**PLANNED UNIT DEVELOPMENT &
SUBDIVISION STAFF REPORT****Date: February 19, 2004**

<u>DEVELOPMENT NAME</u>	Union Planters Subdivision
<u>SUBDIVISION NAME</u>	Union Planters Subdivision
<u>LOCATION</u>	851 East I-65 Service Road South (Southeast corner of East I-65 Service Road South and Airport Boulevard)
<u>PRESENT ZONING</u>	B-3, Community Business
<u>AREA OF PROPERTY</u>	4.2± Acres
<u>CONTEMPLATED USE</u>	Shared access and shared parking between multiple building sites.
<u>TIME SCHEDULE FOR DEVELOPMENT</u>	Immediate
<u>ENGINEERING COMMENTS</u>	Must comply with all stormwater and flood control ordinances. Any work performed in the right of way will require a right of way permit.
<u>TRAFFIC ENGINEERING COMMENTS</u>	Driveway number, sizes, location and design to be approved by Traffic Engineering and conform to AASHTO standards.
<u>URBAN FORESTRY COMMENTS</u>	Property to be developed in compliance with state and local laws that pertain to tree preservation and protection on both city and private properties (State Act 61-929 and City Code Chapters 57 and 64).

<u>REMARKS</u>	The applicant is requesting Planned Unit Development (PUD) approval to allow shared parking and access betwe

SITE PLAN

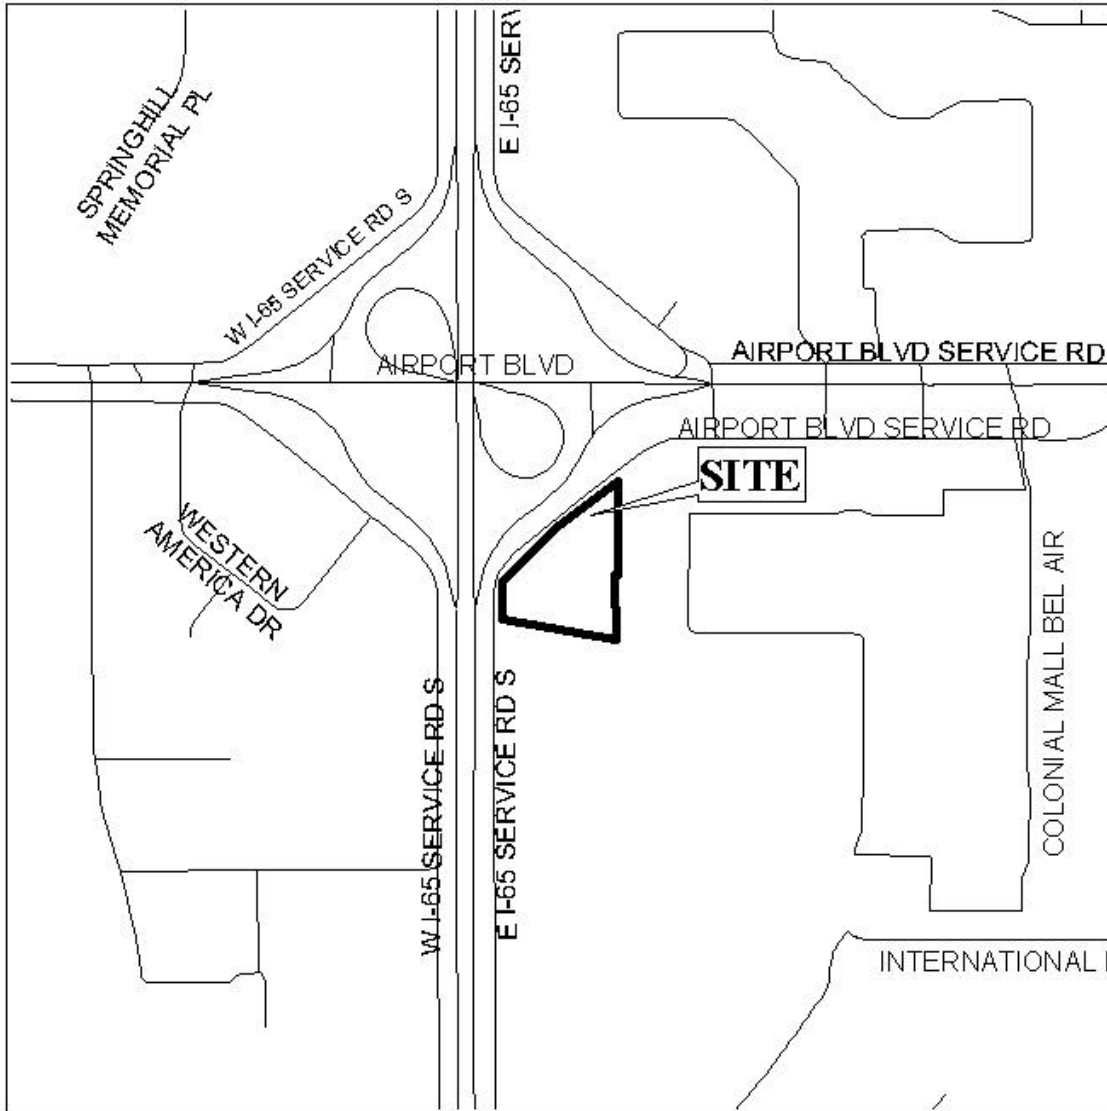
The proposed lot line will extend thru an atrium that connects the bank building with the office building. The site plan does not illustrate any new construction or physical changes to the footprints of the existing buildings. It should be noted that any new construction would require a new PUD approval, and compliance with building codes (possible fire wall along the new property line).

In regard to the proposed subdivision, the site fronts East Beltline Service Road South, a part of Interstate 65, and there is adequate right-of-way in compliance with the Major Street Plan. As no additional construction is proposed, the existing curb cuts should remain as is.

Planned Unit Development: Based upon the preceding, this application is recommended for approval subject to the following conditions: 1) any new additions will require a new PUD; and 2) full compliance with all municipal codes and ordinances.

Subdivision: Based upon the preceding, this application is recommended for approval.
